DRAFT MEMORANDUM

TO: Tera Guetter
Pelican River Watershed District

FROM: Todd Shoemaker, PE

SUBJECT: Downtown Detroit Lakes water quality treatment assessment

FIG 3-8

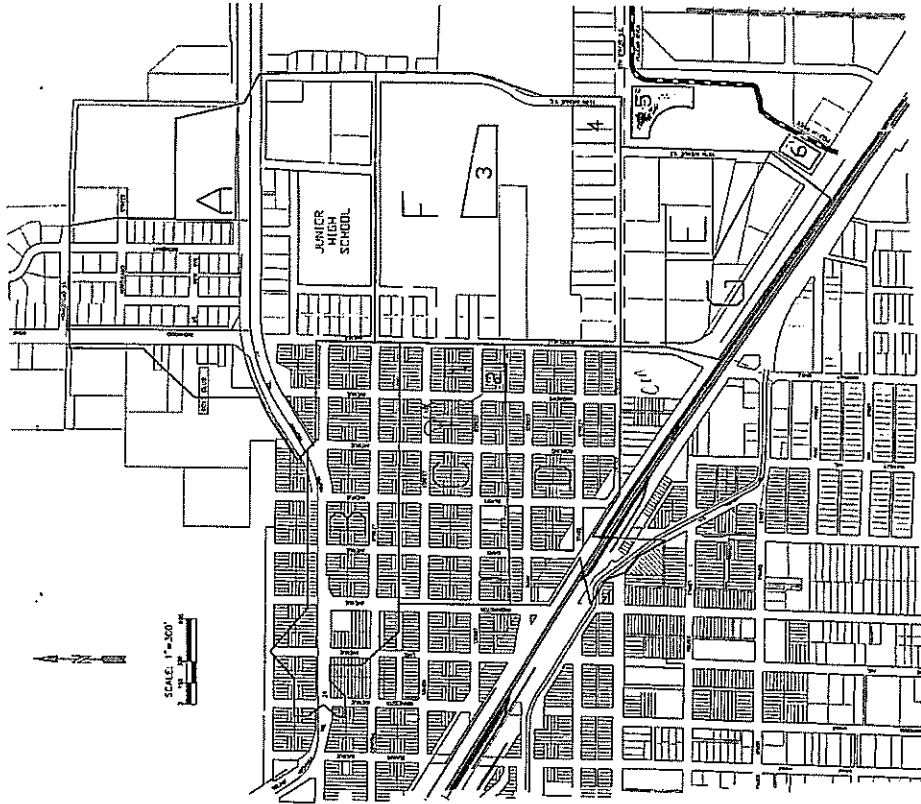
Future redevelopment is expected within subwatersheds "West Central 4," "Substation 1," "Central Market," and "Roosevelt 3" as shown on Figure 1. (MnDOT Figure 3-8 from their November, 2006 TH 10 Phase 3 permit application to the PRWD.)

As part of Phase 3 of the US Highway 10 construction project, MnDOT proposes to construct two new ponds (Substation and Roosevelt) and connect these to the previously constructed Industrial Park Pond (Pond 6 noted above). Initial submittals by MnDOT indicate that this pond system will achieve approximately 54% total phosphorus removal.

It is likely that the excess removal (4%) will be used to "balance" treatment across the MnDOT project to achieve the 50% total phosphorus removal requirement. If that is true (the MnDOT permit has not yet been approved by the PRWD), it is not possible for the excess removal (4%) of the MnDOT ponds to be "traded" to the downtown development area draining to the previously constructed PRWD ponds.
